Wichita-Sedgwick County Metropolitan Area Planning Department

March 19, 2010

RE: BZA2010-10: Sign Code Adjustment to permit an electronic message sign for an institutional use on property zoned TF-3 Two-Family Residential.

LED Monument Sign

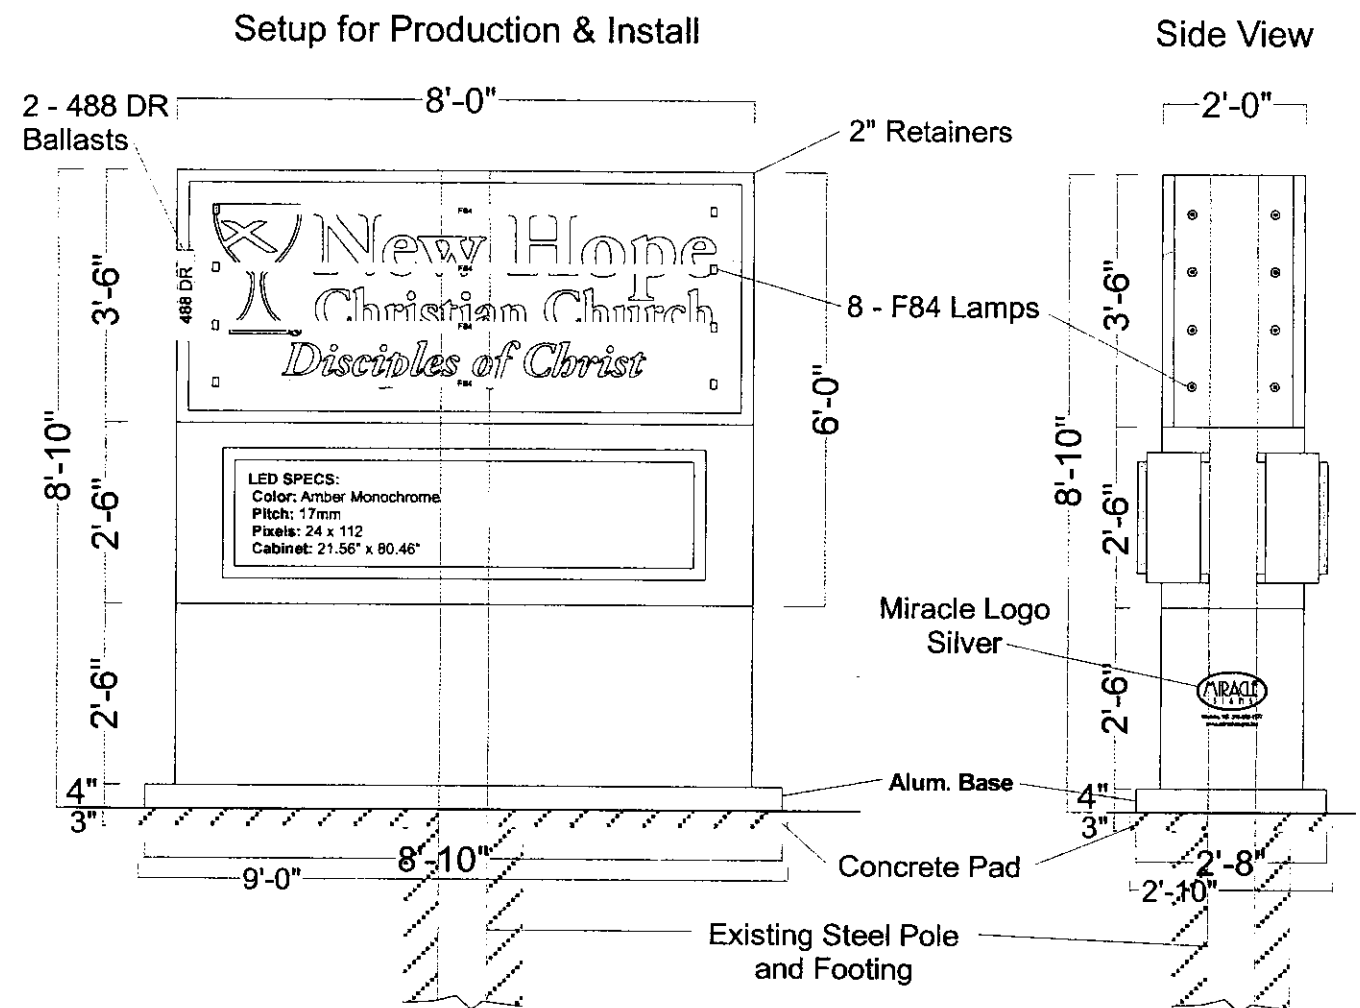
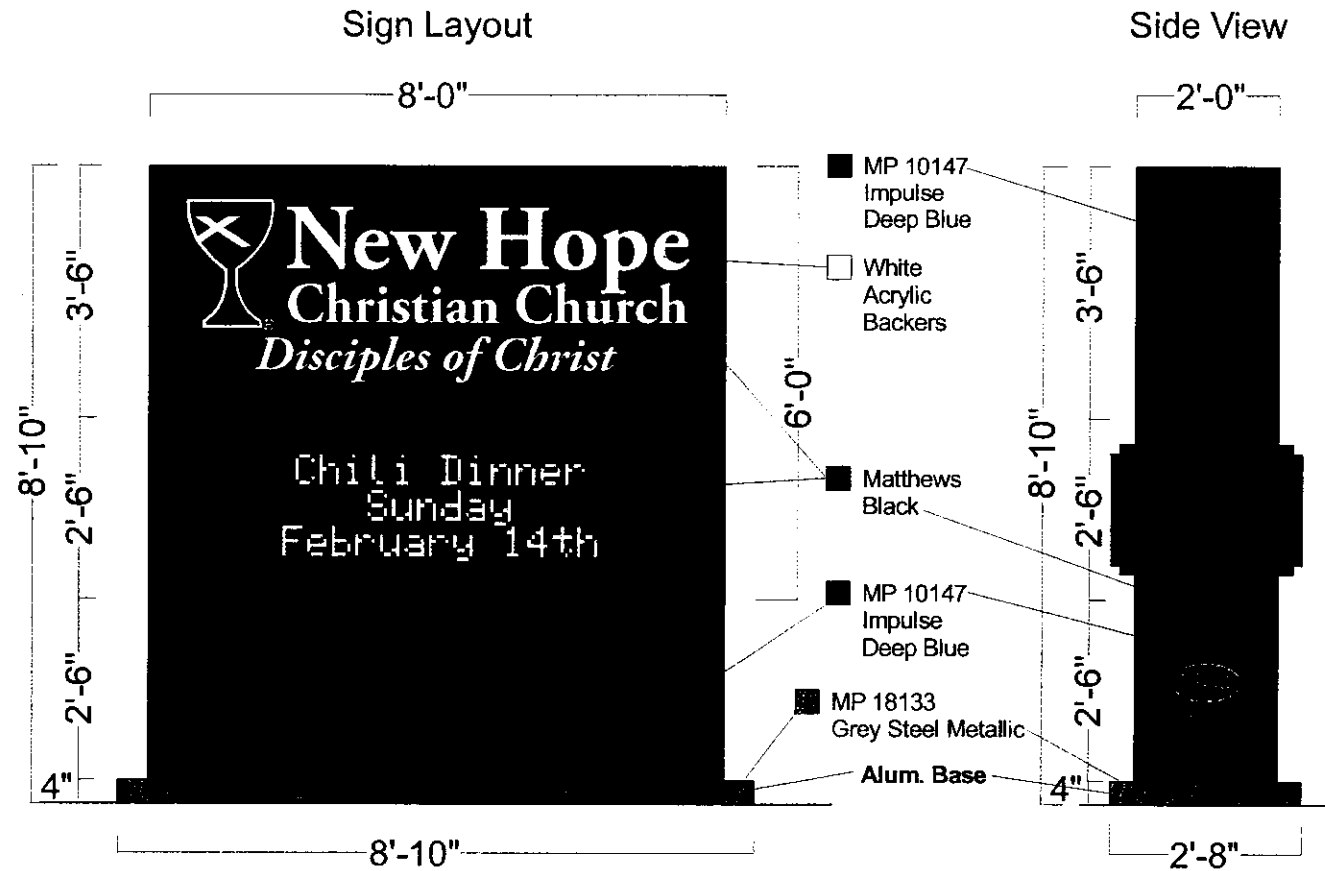
We have reviewed your request for a Sign Code Adjustment to permit an electronic message sign for an institutional use on the aforementioned property. From reviewing your application, we understand that you propose a 2'6" by 8' LED sign within a larger sign, on a property formerly used as a school (WATC) that is being converted to a church, New Hope Christian Church (formerly known as Broadway Christian Church). The new monument style sign will replace the existing WATC sign.

- 1) Impact on existing uses in surrounding areas: Existing uses in the surrounding area include multi-family residential four-plexes west of George Washington Boulevard on property zoned MF-29 Multi-Family Residential ("MF-29"). Most of the area to the north, east and southeast is single-family residential on property zoned TF-3. The sign is situated along George Washington Boulevard to reduce its visibility to these low-density residential areas except for the two homes on Grail Street closest to George Washington Boulevard. As shown on the attached elevation included with this request, the sign will be eight feet in height, which is less than the 20-foot height of the current sign.

- 2) Compatibility with existing or permitted uses on abutting sites: Adding electronic message capability to the sign should not reduce compatibility of the sign with surrounding uses, as the sign will not be permitted to flash or display moving images, and graphics changes will be restricted to one change per second or slower.

- 1) The sign shall be in conformance with the approved elevation.
- 2) No animated, flashing or moving images or text shall be displayed on the sign; the sign shall not make copy or graphics changes faster than once per second.
- 3) Portable signage shall not be permitted on the subject property.
- 4) If the Zoning Administrator finds that there is a violation of any of the conditions of the Zoning Adjustment, the Zoning Administrator, in addition to enforcing the other remedies set forth in the Unified Zoning Code, may, with the concurrence of the Planning Director, declare that the Zoning Adjustment is null and void.
